Westwind – Stormwater Management (Contract 9130, MUNIS 13921)

ADDENDUM No. 1: Replace boundary markers for split rail fence per SDD 2.20

**EXHIBIT OF IMPROVEMENTS:
WESTWIND - PHASE 2
BOARD OF PUBLIC WORKS 05/20/2026**

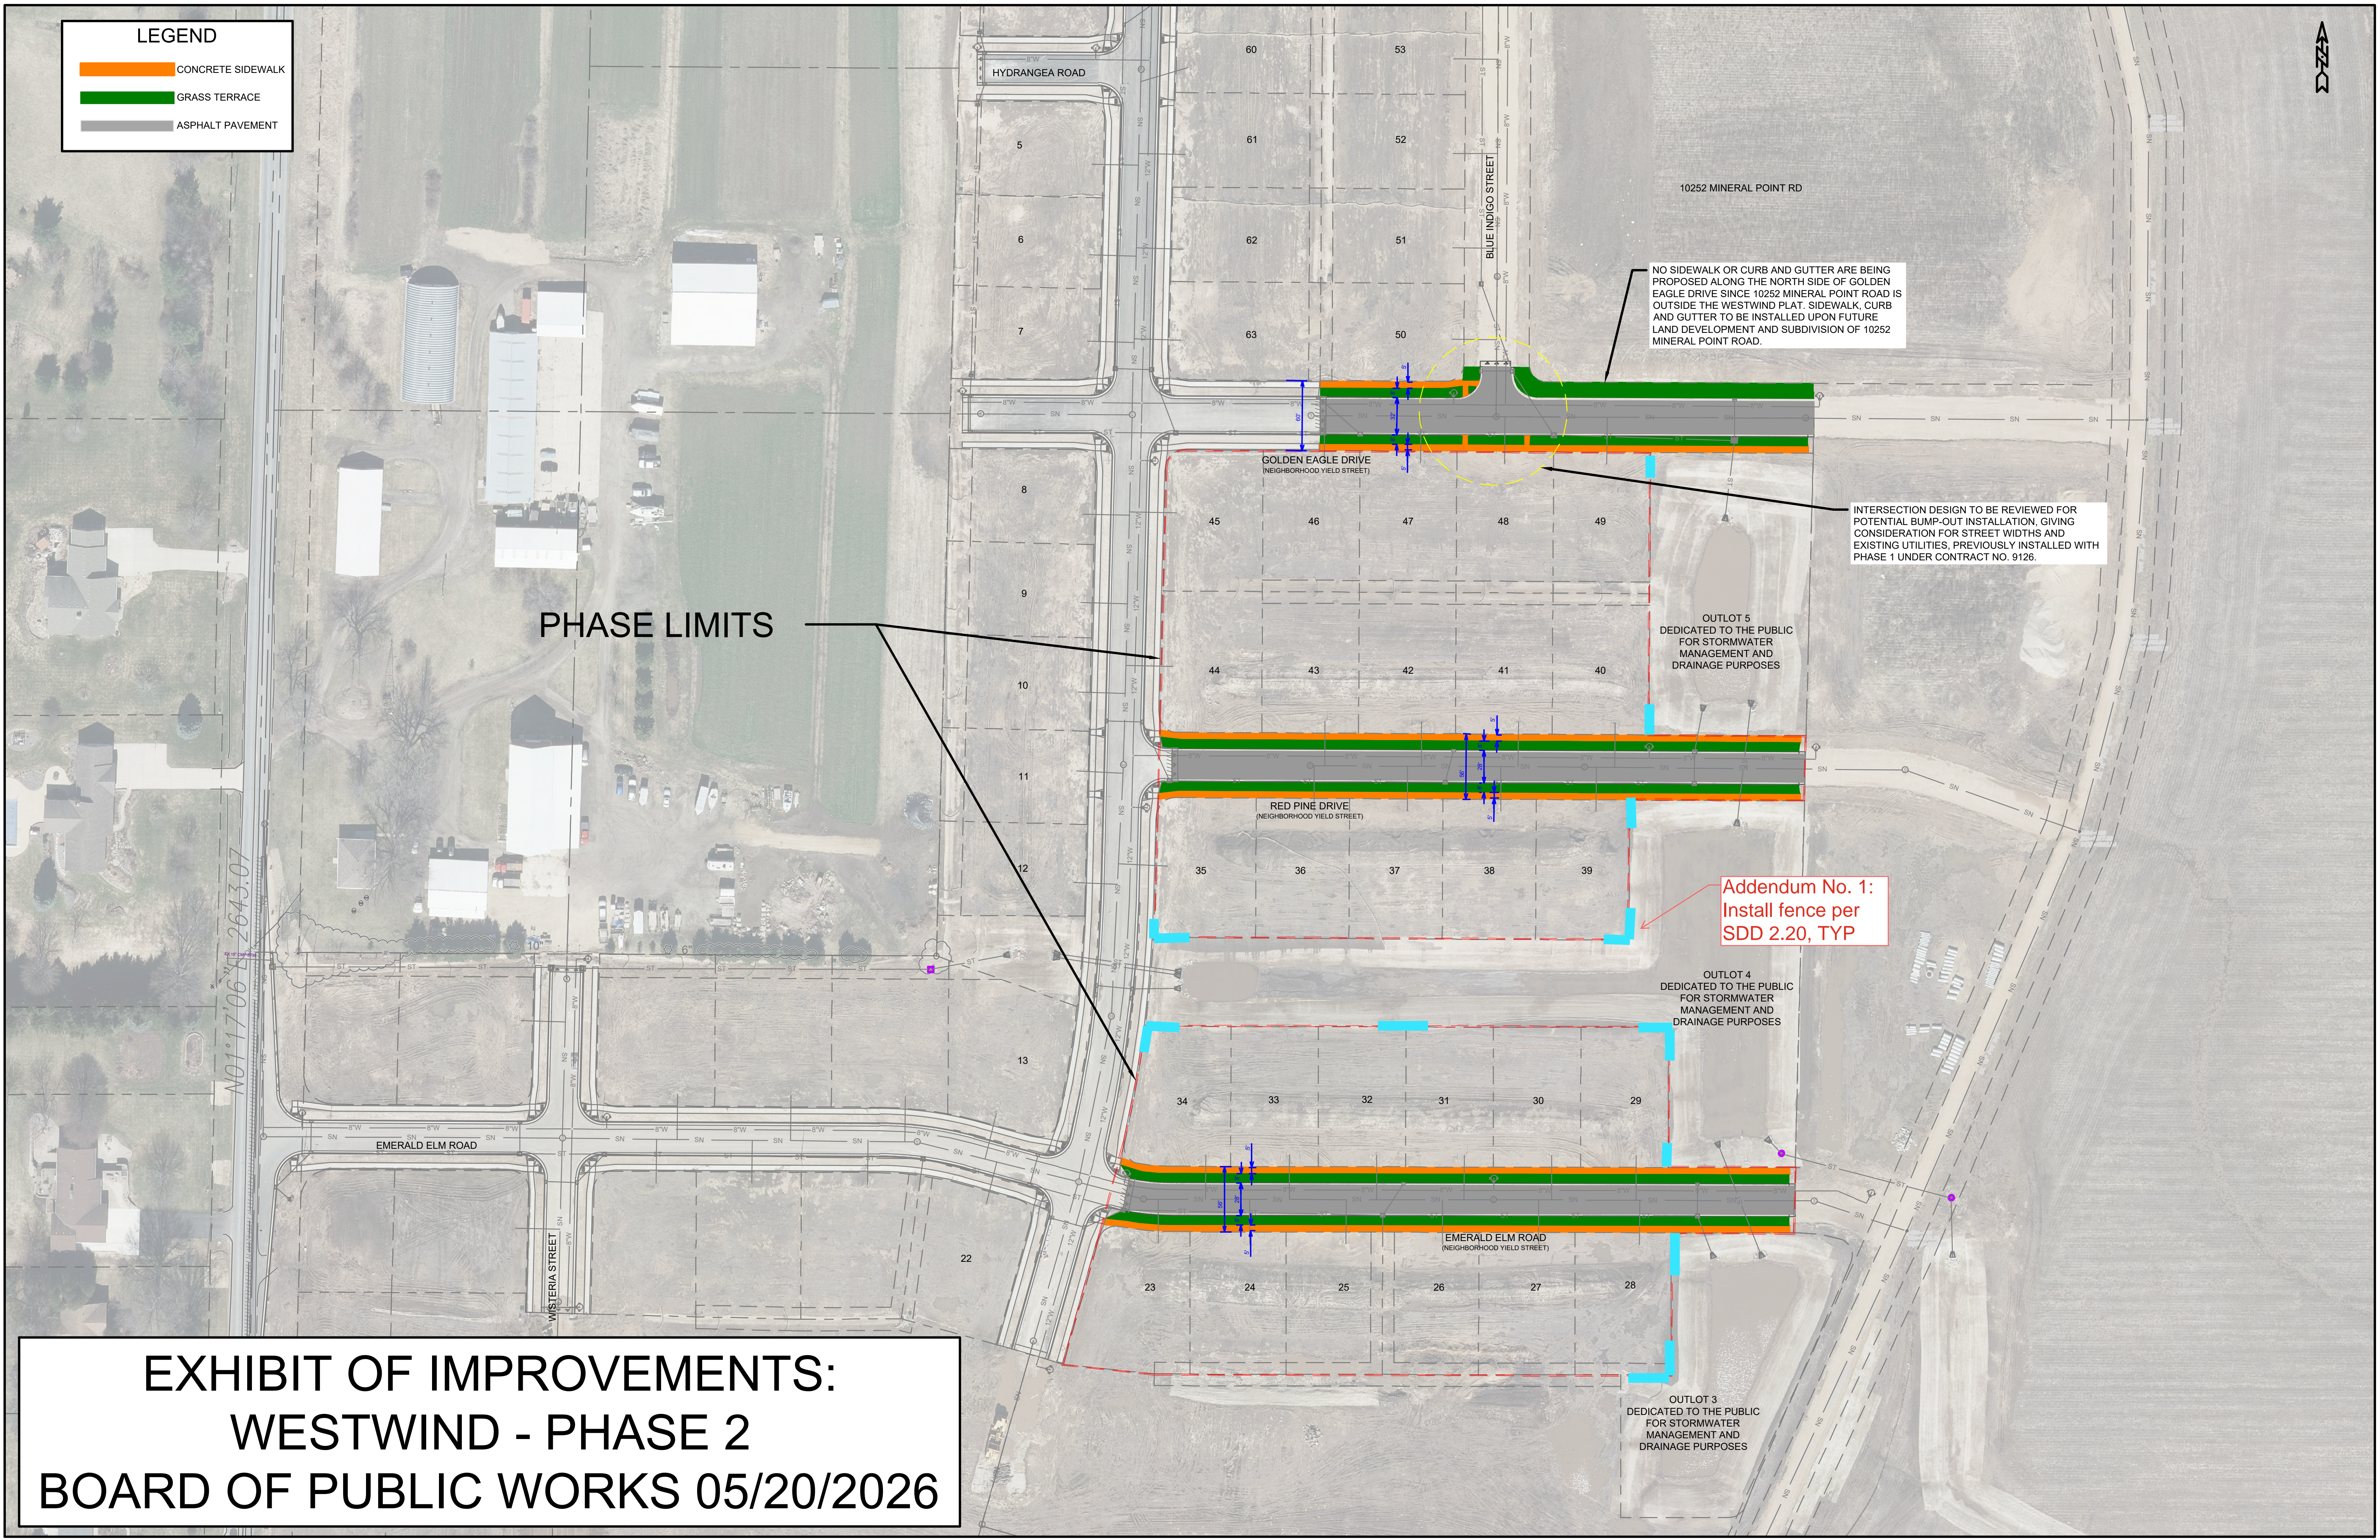
Addendum No. 1:
Install fence per
SDD 2.20, TYP
